IN THE MATTER of the applications by
HiRock Limited to the Palmerston North City
Council (LU 6962) and the Manawatū -
Whanganui Regional Council (APP-
2022203991.00) for resource consents
associated with the expansion and
operation of an existing quarry at 167-251
Kendall's Line, Palmerston North

REPORT TO THE COMMISSIONER

SECTION 42A REPORT OF NATASHA CACILIA ADSETT – PLANNING

30 May 2023

Figure 1: Figure showing my interpretation of the current discharge regime at the Linton Quarry.

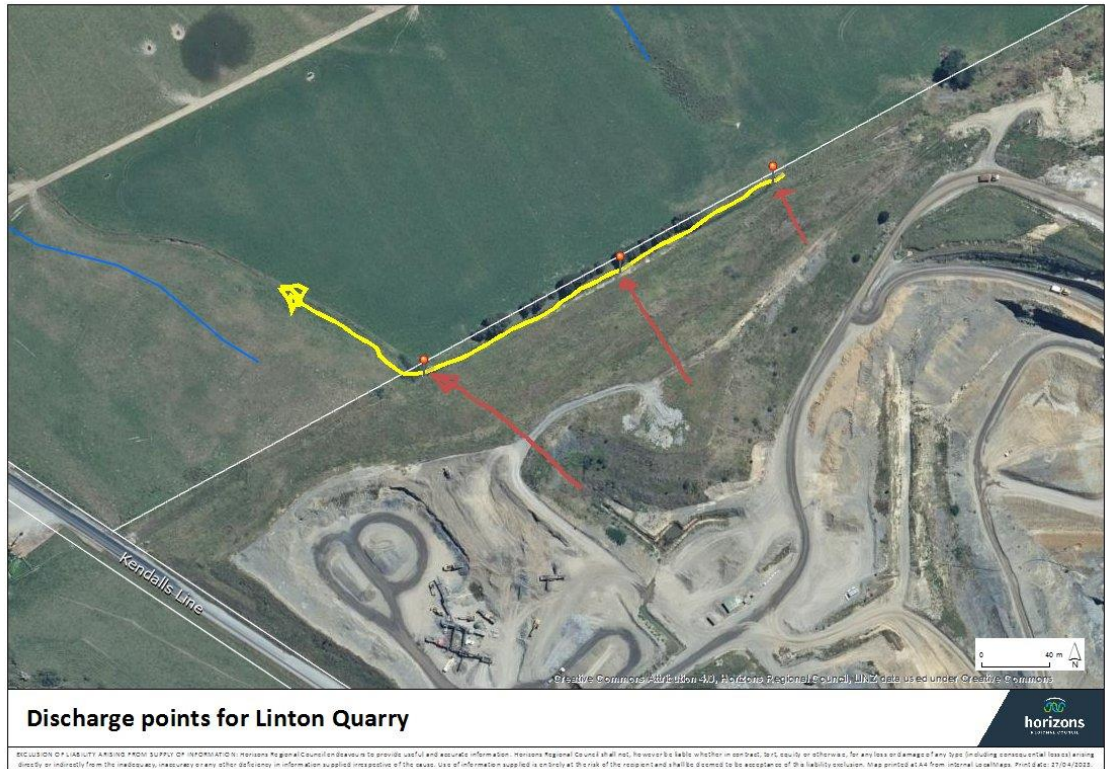
11. Based on the application, Section 92 response and the site visit, my understanding of the current discharge is that there are three discharge points (marked as red lines in Figure 1) through the north-western noise bund which discharge into a waterway that resembles a dam or pond marked with a yellow line (Ponding area in Figure 1). This “pond” appears to start at the most northern discharge point and runs parallel to this bund. This Raupō Pond at the time of the site visit appeared to be at capacity and the water highly turbid, based on my visual inspection (rather than formal measurements), and therefore, the discharge appeared to be poorly treated as can be seen in Figure 2. This pooled water in the ponding area appeared to be collecting all the discharge water from the site and poorly acting as a drain, flowing toward Kendall’s Line and through a small stand of Raupō which turns parallel to Kendall’s Line and flows through the farmland. This is the point at which I interpret the beginning of the unnamed tributary or “farm drain” as described by the applicant throughout the application. The waterway that flows parallel to Kendall’s Line is proposed to be the receiving environment. At the time of the site visit the discharge appeared to be flowing substantially due to the accumulation of discharged water in the ponded area. It is my understanding that the current discharge points will be consolidated into one sediment retention pond. This will mean there is no ponding effect, and the water will be discharged directly to the farm drain and can be monitored more effectively. Photos from the site visit of the waterway and the ponded area have been included below as figures.

12. A point of disagreement during expert conferencing was the nature of the discharge. In my opinion, the discharge has the potential to be more continuous than intermittent in nature. As outlined in the application this is due to the way the pit is utilised with the management of the storm water on site. In the Erosion Sediment Control Plan (ESCP) it states the quarry pit has not been included in the catchment area for the sediment retention pond (SRP1 in the JWS) design. In the ESCP, it proposes during rainfall events that the water run-off collected in the pit will not be pumped to the sediment retention pond and will be pumped to the water storage pond. Therefore, during these rainfall periods the sediment retention pond will be discharging from the water collected within the 7.2 hectare catchment it is designed for. During rainfall events we can expect the water storage pond will be receiving run-off from the clean water drain/diversion on the southern side of the quarry. In the ESCP it is proposed in order to manage the water in the pit area, *“the water is pumped into the sediment retention pond or the water storage pond whichever has capacity”*. The pumping of the water collected in the quarry pit to the sediment retention pond could result in a more continuous discharge flow or one not reflecting the intermittent nature of rainfall events as outlined in the application. I have not been provided with any evidence or monitoring results regarding the sediment retention pond discharge frequency and therefore, cannot agree that it will be intermittent as information contained within the application would suggest otherwise. Despite the difference in opinions if the monitoring conditions are prescribed and worded in such a way that when a discharge is occurring it will be monitored regardless of the cause i.e. pumping or rainfall events then the potential effects caused by the

discharge will be captured. Then with the implementation of the proposed discharge standards the potential effects will be managed.

Figure 8: This map shows the quarry site in 2005 and the two channels are clearer. The channel flowing parallel to Kendall's Line has a significant amount of water pooled in behind the race.

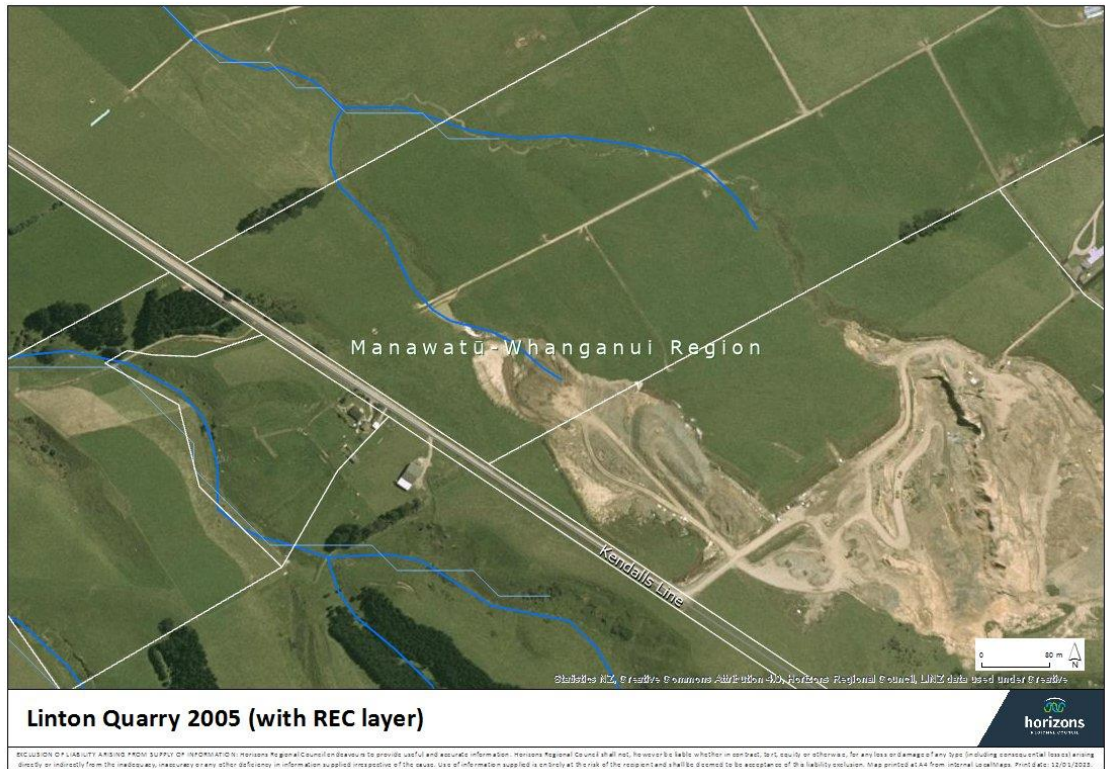
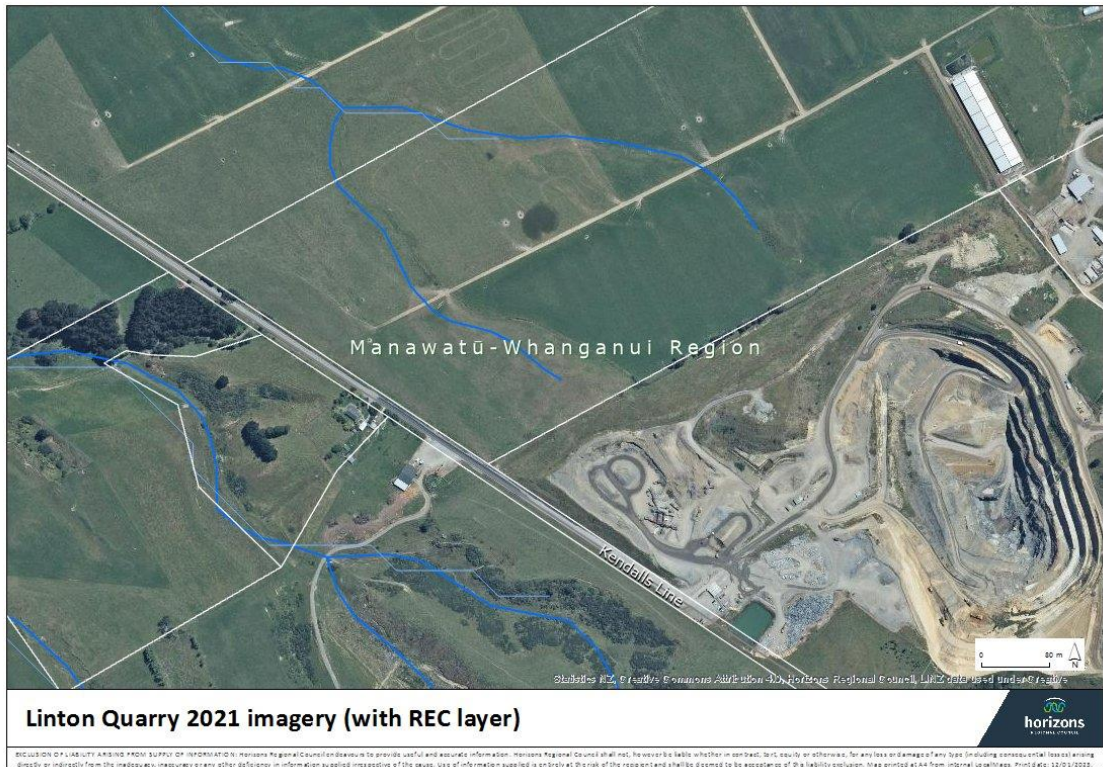
21. There is a lack of empirical information and monitoring data for the waterway both pre-quarry and on the state of the current storm water discharge quality. Therefore, it was agreed by both parties during a Zoom meeting on the 15th of December 2022 that a conservative approach should be used when assessing this application and when forming conditions around treatment, standards and monitoring of the discharge.
